**18-03 Olive Street Parking Garage – Trades Bidders**  
**September 27, 2017**

**Addendum #3**

**OLIVE STREET PARKING FACILITY**  
**GREENFIELD, MASSACHUSETTS**  
**Construction Documents – Bid Set**  
**September 6, 2017**

**SKA-003**

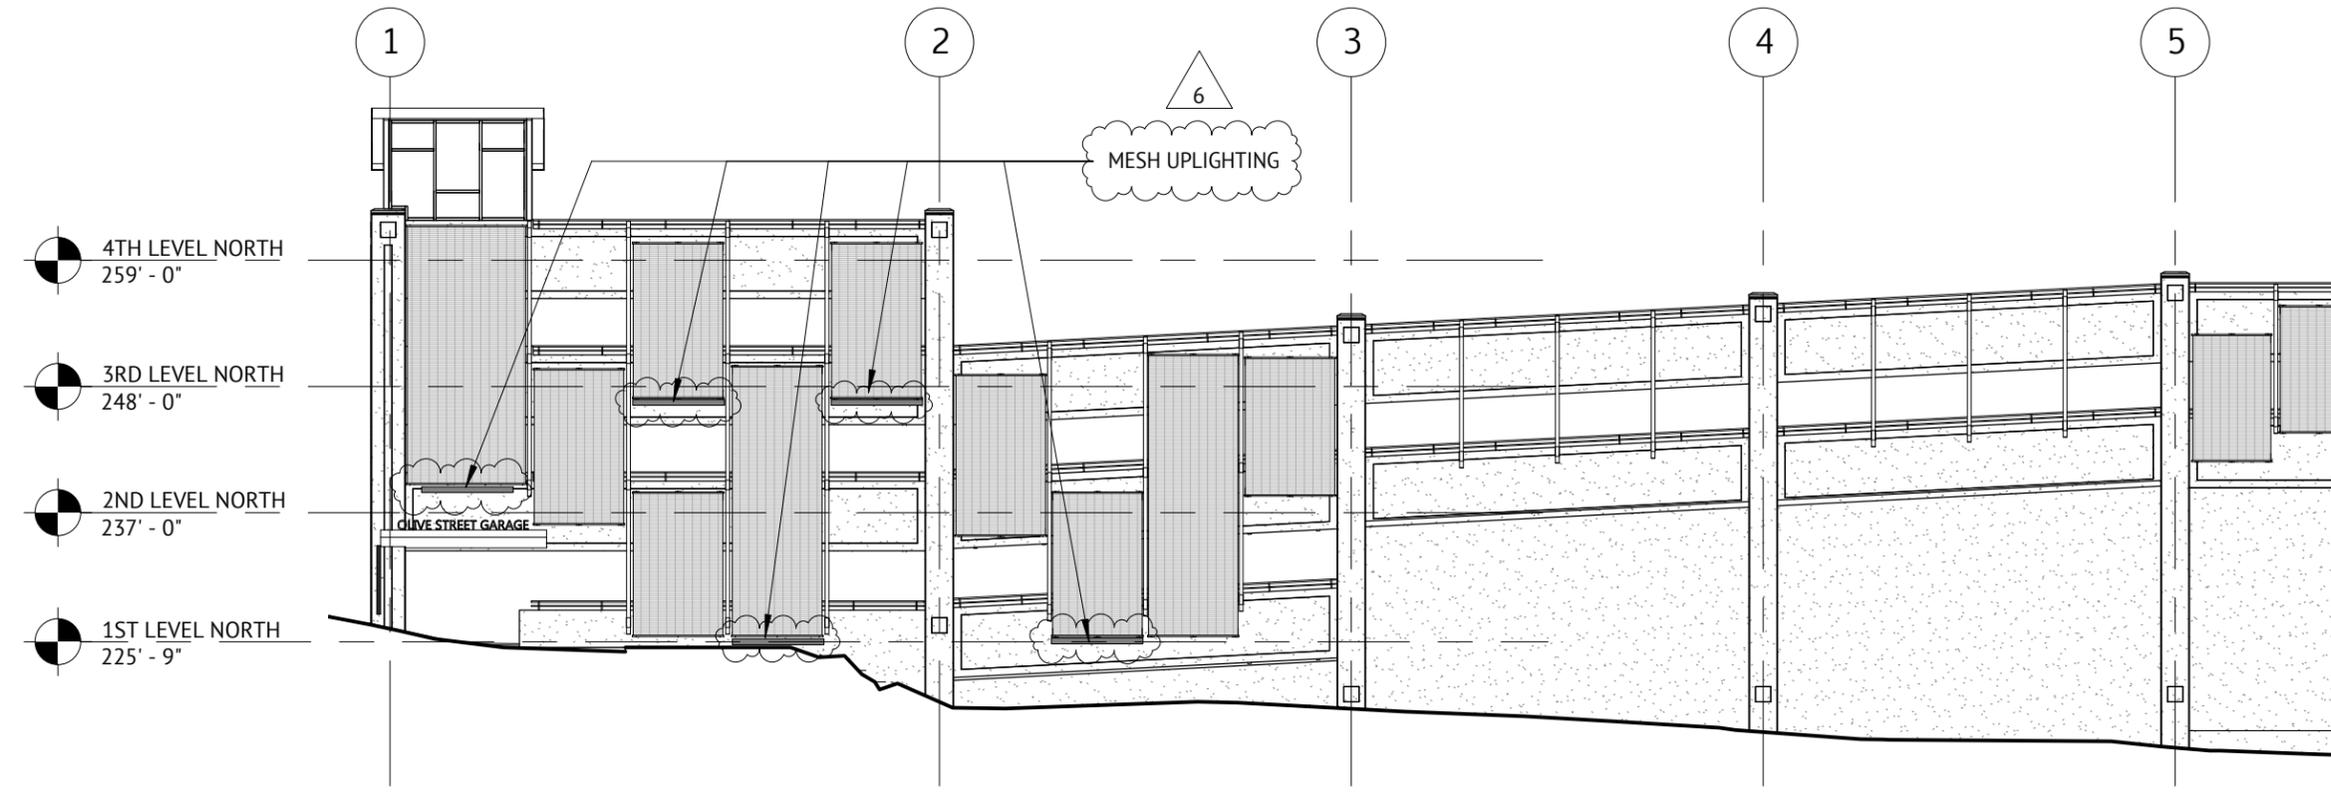
2 MESH UPLIGHTING, EAST ELEVATION  
1/16" = 1'-0"

1 MESH UPLIGHTING, WEST ELEVATION  
1/16" = 1'-0"

REVISION NUMBER	DRAWING REFERENCE
6	2/A201, 2/A202
RFI REFERENCE	RFI REFERENCE
N/A	N/A

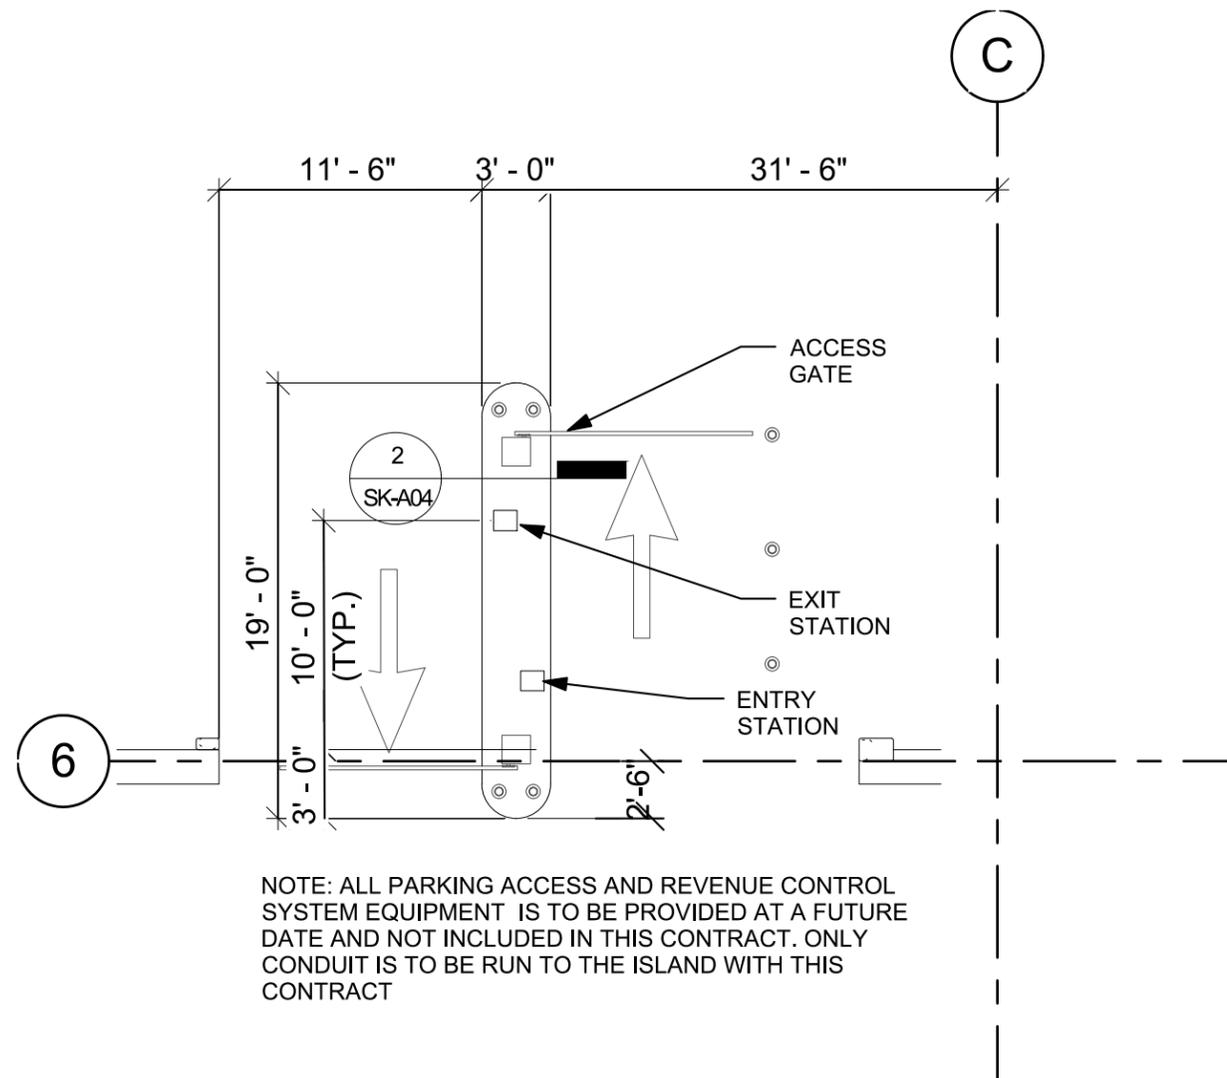
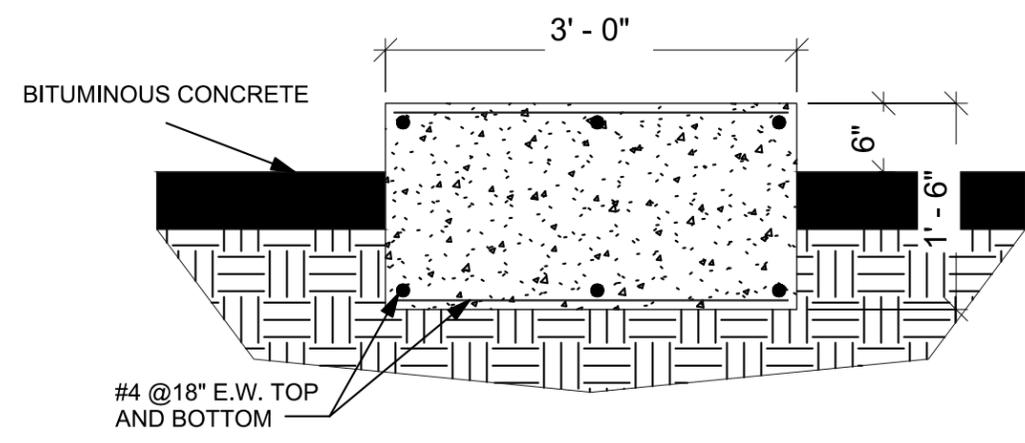
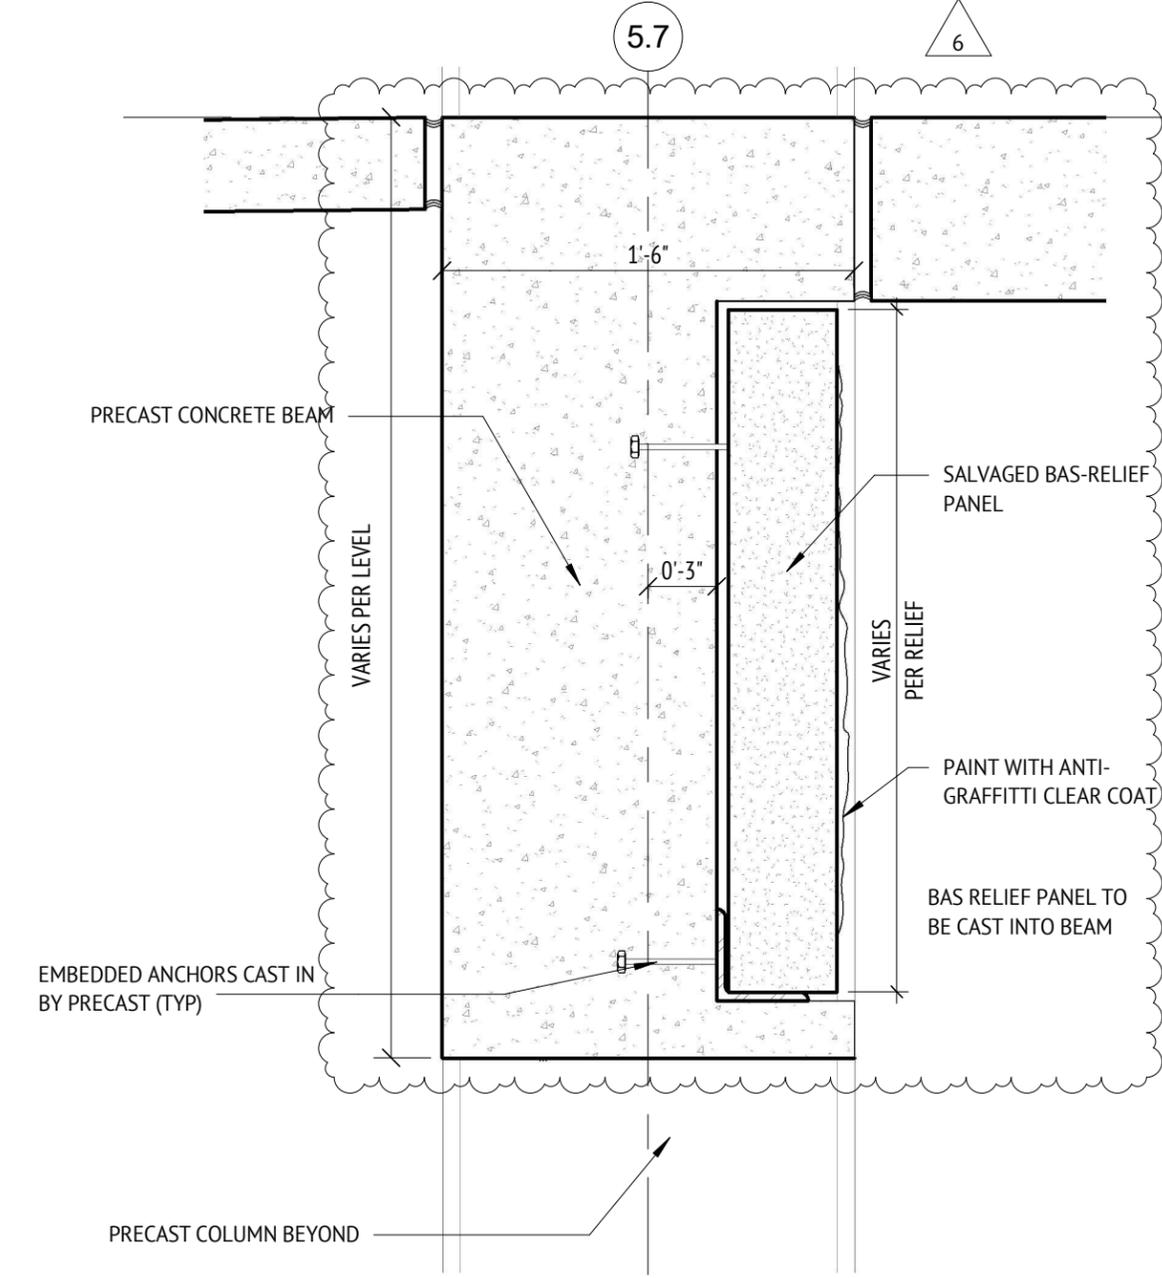
# ENLARGED PARC ISLAND PLAN

NOTE: ALL PARKING ACCESS AND REVENUE CONTROL SYSTEM EQUIPMENT IS TO BE PROVIDED AT A FUTURE DATE AND NOT INCLUDED IN THIS CONTRACT. ONLY CONDUIT IS TO BE RUN TO THE ISLAND WITH THIS CONTRACT

# CIP ISLAND SECTION

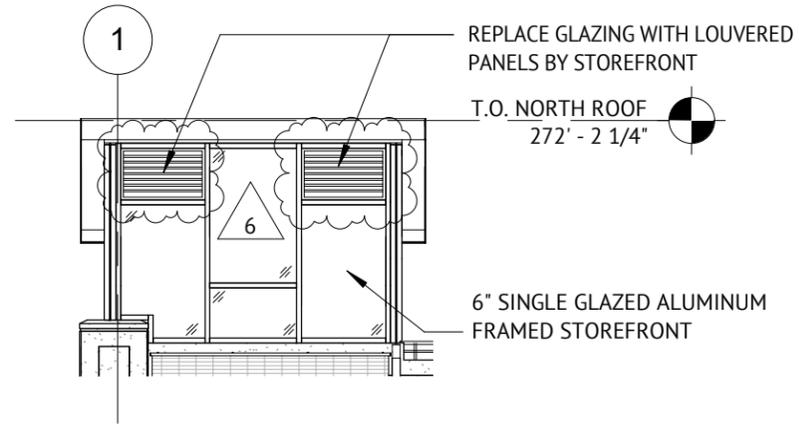
1 BAS RELIEF TYP. MOUNTING DETAIL, REV.  
 1 1/2" = 1'-0"

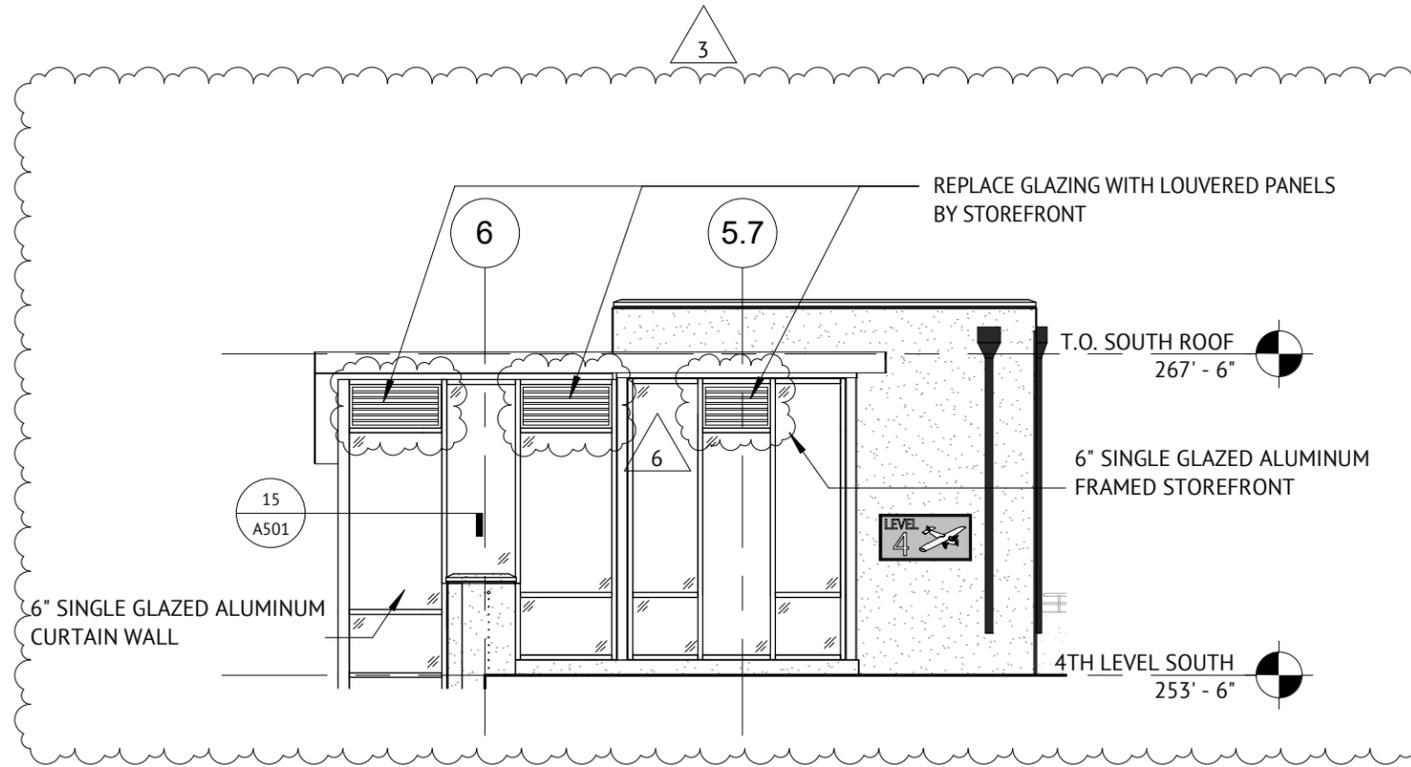
1 WEST ELEVATION - NORTH STAIR REV.  
1/8" = 1'-0"

2 EAST ELEVATION, SOUTH STAIR REV.  
1/8" = 1'-0"

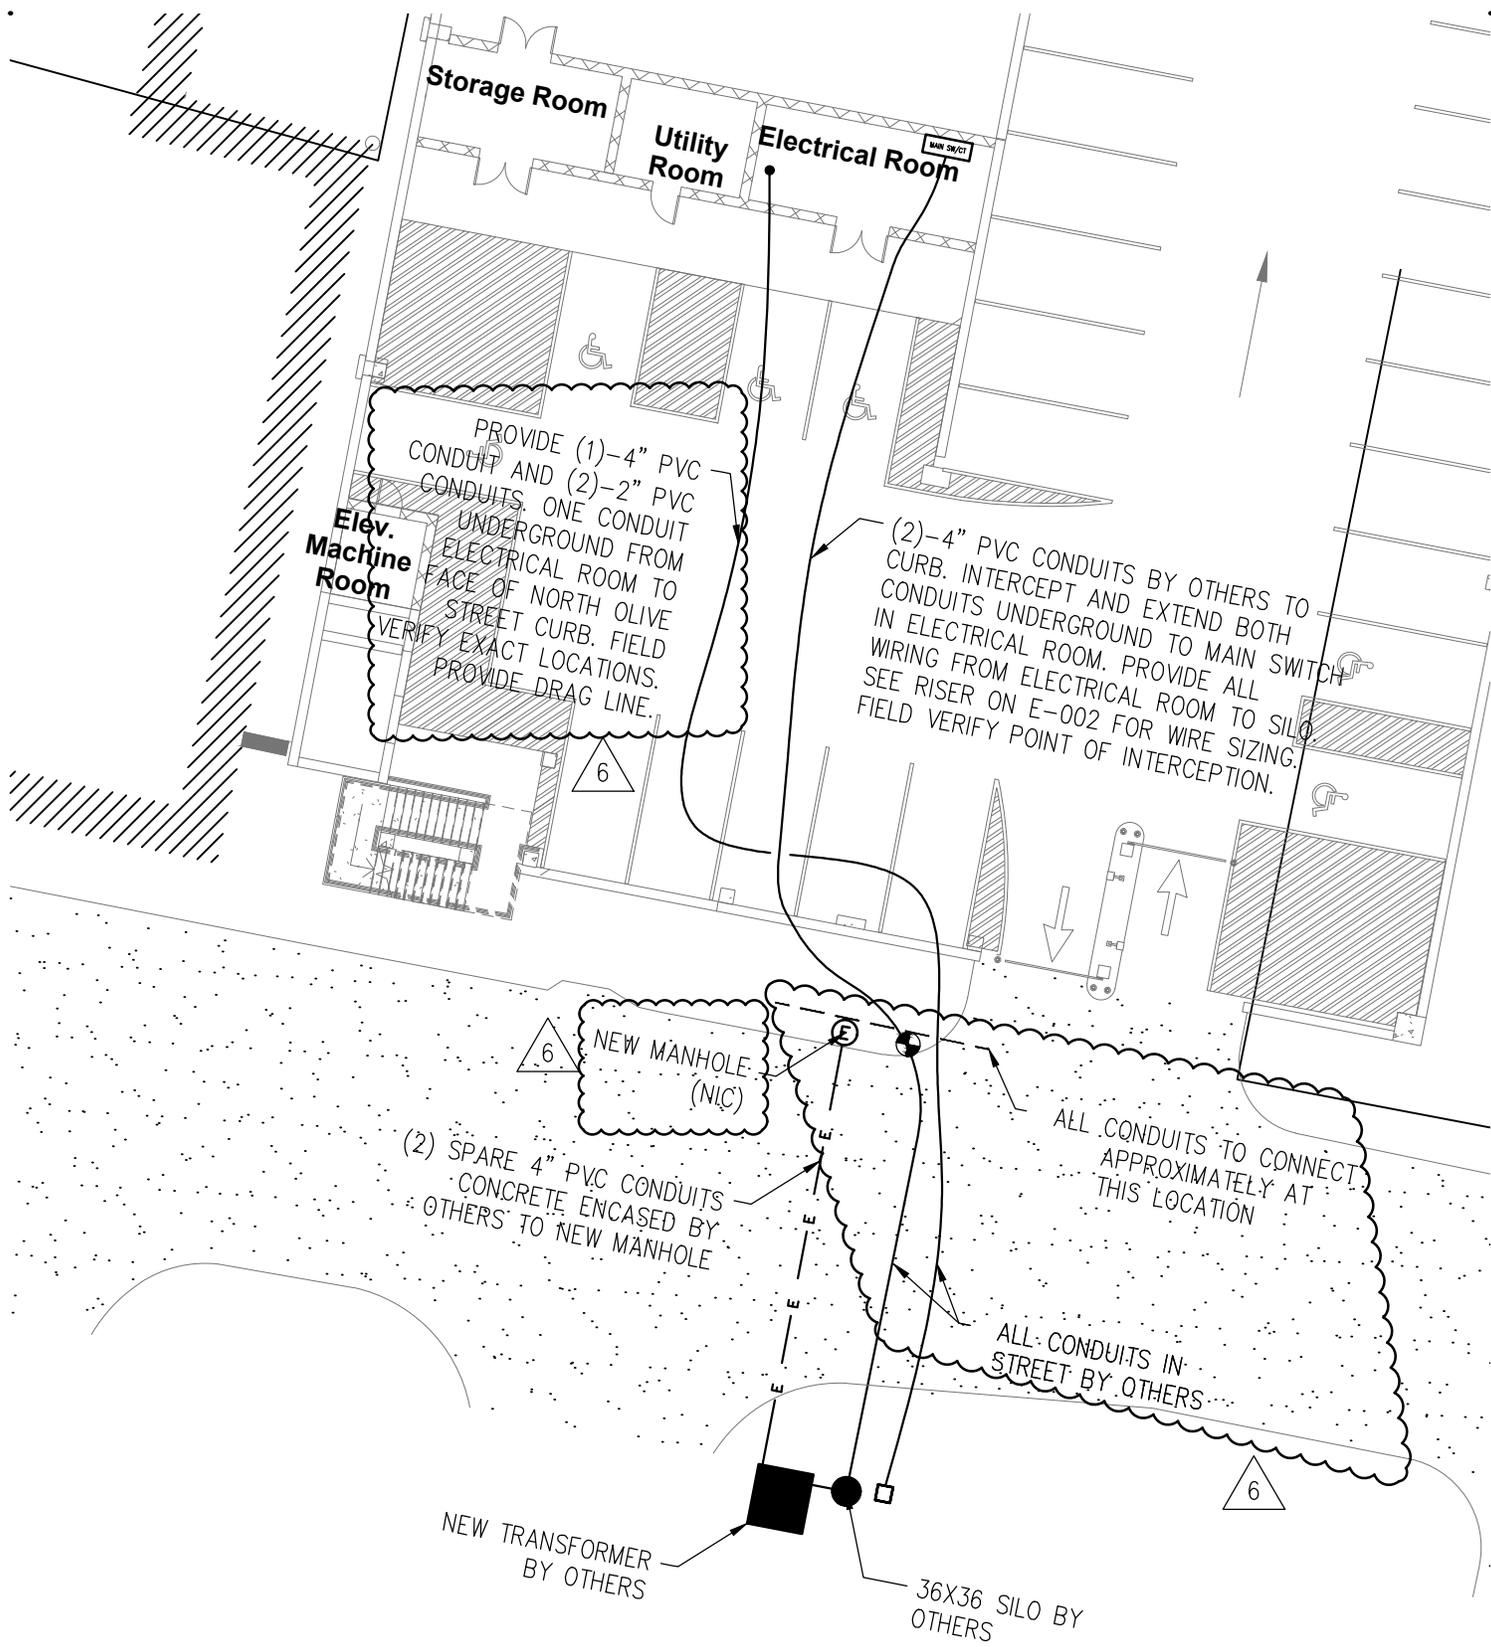
<b>SKETCH TITLE</b> ELECTRICAL SITE PLAN - CONDUITS	<b>REVISION NUMBER</b> 6	<b>DRAWING REFERENCE</b> E-003	
	<b>PROJECT</b> OLIVE STREET GARAGE/ GREENFIELD, MA	<b>PROJECT NUMBER</b> 20-16105.01-1	<b>ISSUED BY</b> JWA	<b>RFI REFERENCE</b> N/A
A DIVISION OF DESMAN, INC. <small>NEW YORK CHICAGO WASHINGTON, D.C. HARTFORD BOSTON CLEVELAND</small> 18 Tremont Street - Suite 300 Boston, Massachusetts 02108 Tel: (617) 778-9882 Fax: (617) 778-9883	<b>SCALE</b> AS NOTED	<b>ISSUE DATE</b> 09-26-2017	<h1>SKE-001</h1>

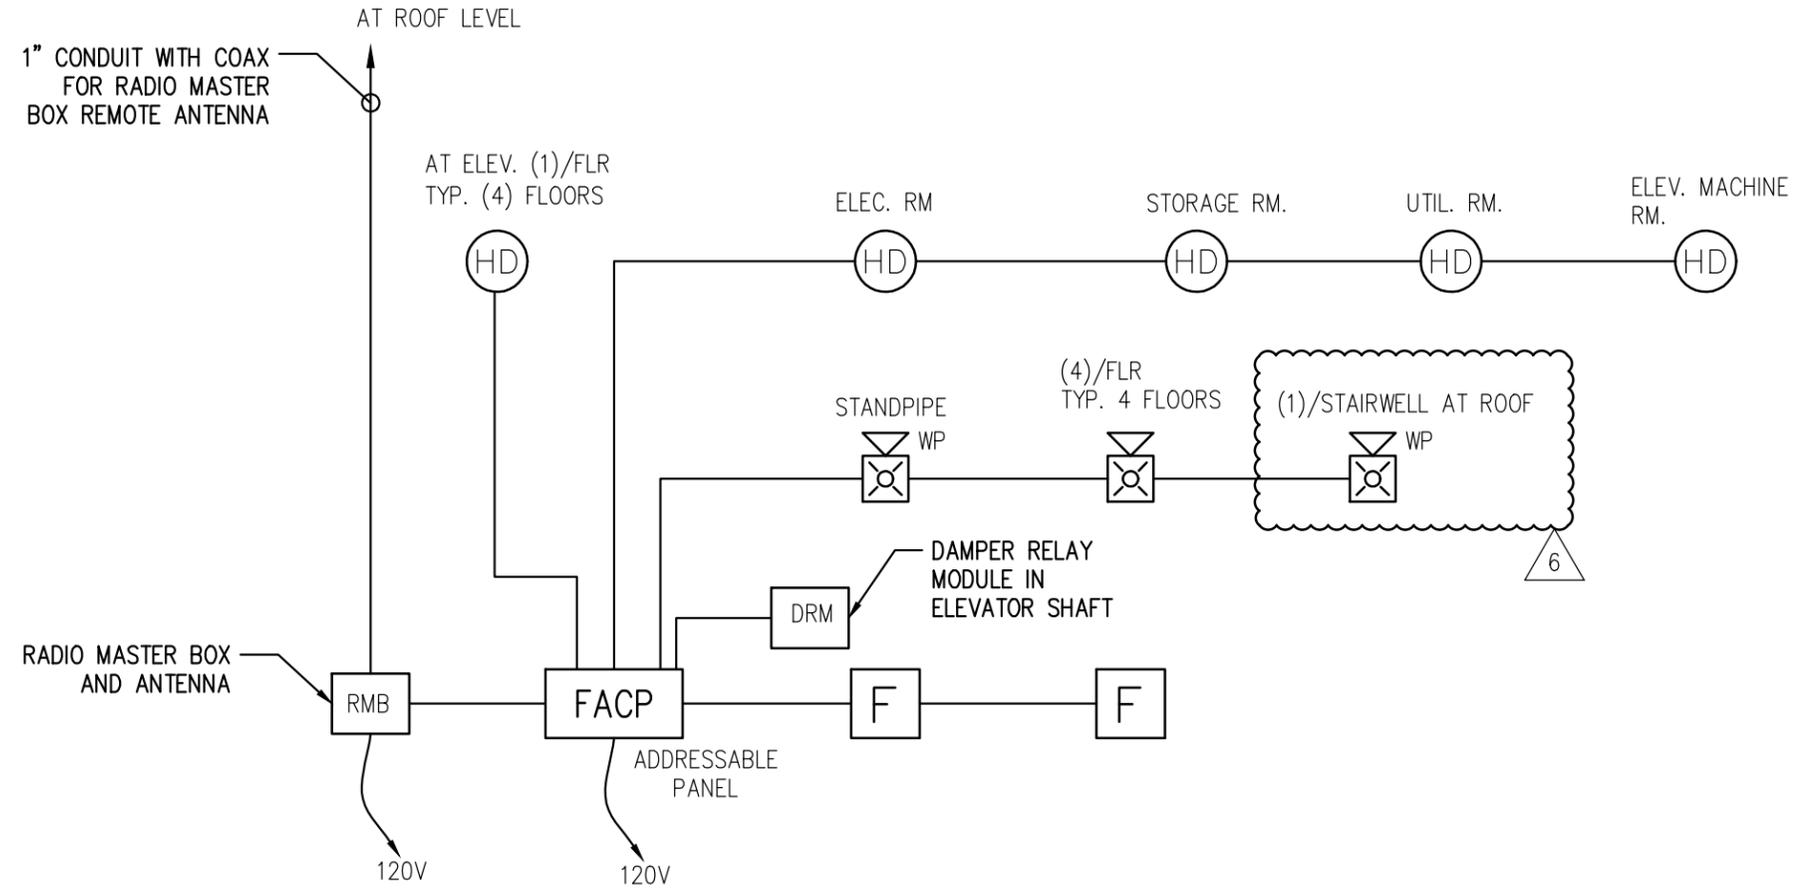
**1** fire alarm riser diagram  
n.t.s.

1. RADIO MASTER BOX TO BE AES - #7706-ULF PER TOWN OF GREENFIELD FIRE DEPARTMENT REQUIREMENTS. (REP. - EASTON ELECTRONICS - 800-879-3117)
2. PROVIDE REMOTE ANTENNA AT ROOF LEVEL OF GARAGE MOUNTED ABOVE STAIRWELL ROOF.
